SHOP DRAWING TRANSMITTAL

FIU PEDESTRIAN BRIDGE 434688-1-58-01
PT DECK, CANOPY AND TRUSS SHOP DRAWING
SUMMARY OF REVIEW COMMENTS BY CEG 6/26/2017 from FDOT D6

REFERENCE: UniversityCity Prosperity Project
Project ID BT-904
Submittal #000462-1.B, Post Tensioning – Deck, Canopy, Truss
(Revised)
FIGG Project No. 2262.06

Post Tensioning (Deck, Canopy & Truss)

SCALE: VARIES
 JOB NO: 423729
 SHEET: PT04

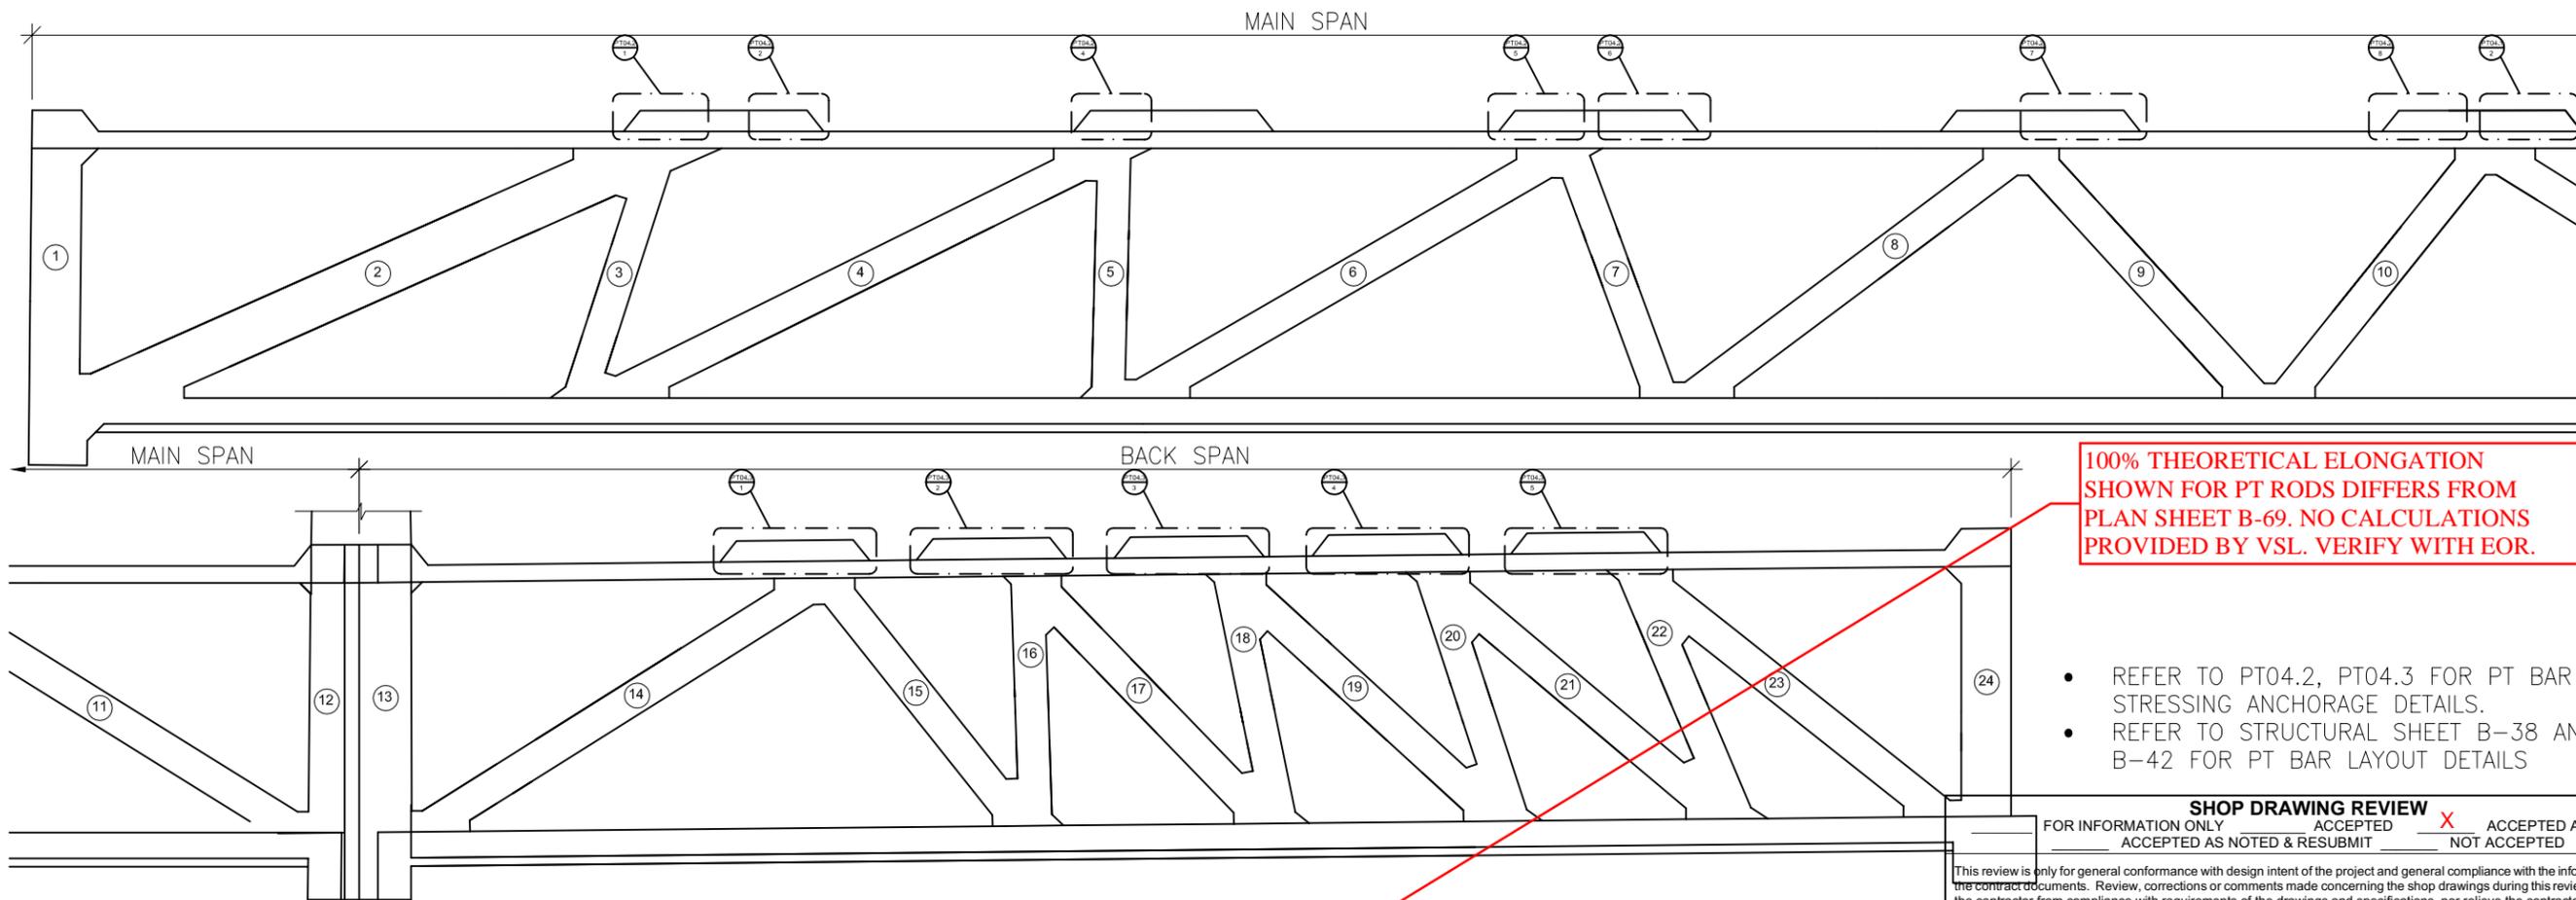
| <u>SHEET ID</u> | <u>COMMENT</u> |
|-----------------|--|
| PT04 | BEARING PLATE SIZES SHOWN DIFFER FROM SHEETS B-38 & B-42. VERIFY W/ EOR. |
| PT04 | 100% THEORETICAL ELONGATION SHOWN FOR PT RODS DIFFERS FROM PLAN SHEET B-69. NO CALCULATIONS PROVIDED BY VSL. VERIFY W/ EOR. |
| PT04 | DIAPHRAGM PT BAR. EOR TO VERIFY JACKING FORCE, STRESS SEQUENCE, PT BAR LENGTH AND ELONGATION SHOWN. INFORMATION NOT IN RFC PLANS. |

Add note referencing Sheets B-109 & B-110 for overall stressing sequence.

DIAPHRAGM PT BAR. EOR TO VERIFY JACKING FORCE, STRESS SEQUENCE, PT BAR LENGTH AND ELONGATION SHOWN. INFORMATION NOT IN RFC PLANS.

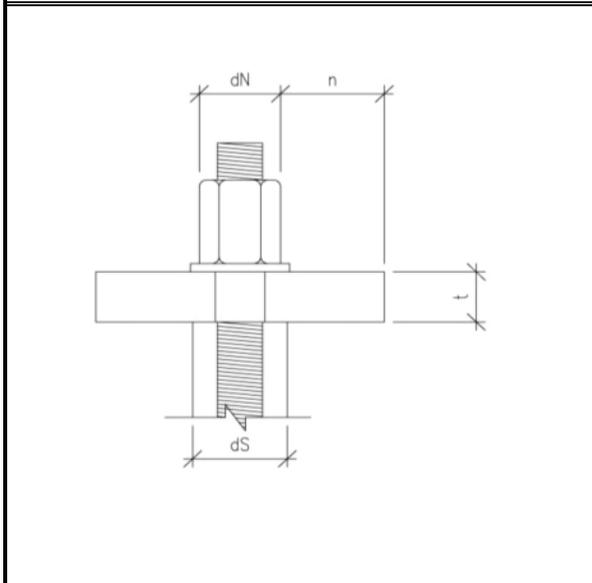
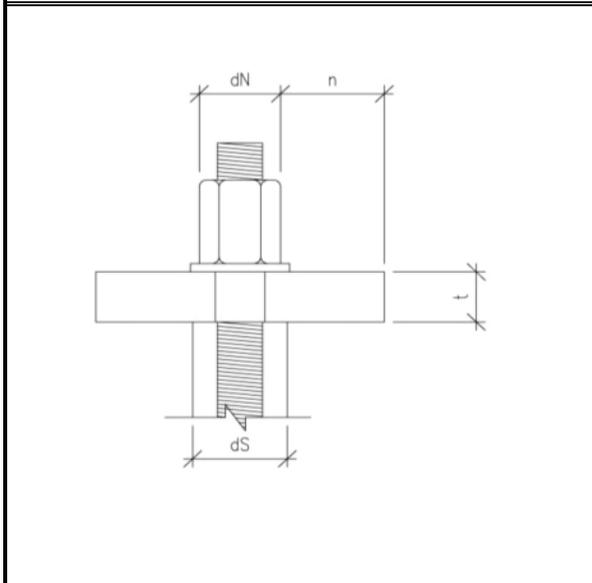
PT BAR BEARING PLATE CALCULATIONS:

CALCULATIONS WERE PERFORMED USING BEARING PLATE DIMENSIONS DIFFERENT THAN THOSE SHOWN IN PLANS. EOR TO VERIFY THAT THESE BEARING PLATE DIMENSIONS SATISFY THE DESIGN INTENT.

CALCULATIONS WERE PERFORMED USING BEARING PLATE
DIMENSIONS DIFFERENT THAN THOSE SHOWN IN PLANS.
FOR TO VERIFY THAT THESE BEARING PLATE DIMENSIONS
SATISFY THE DESIGN INTENT.
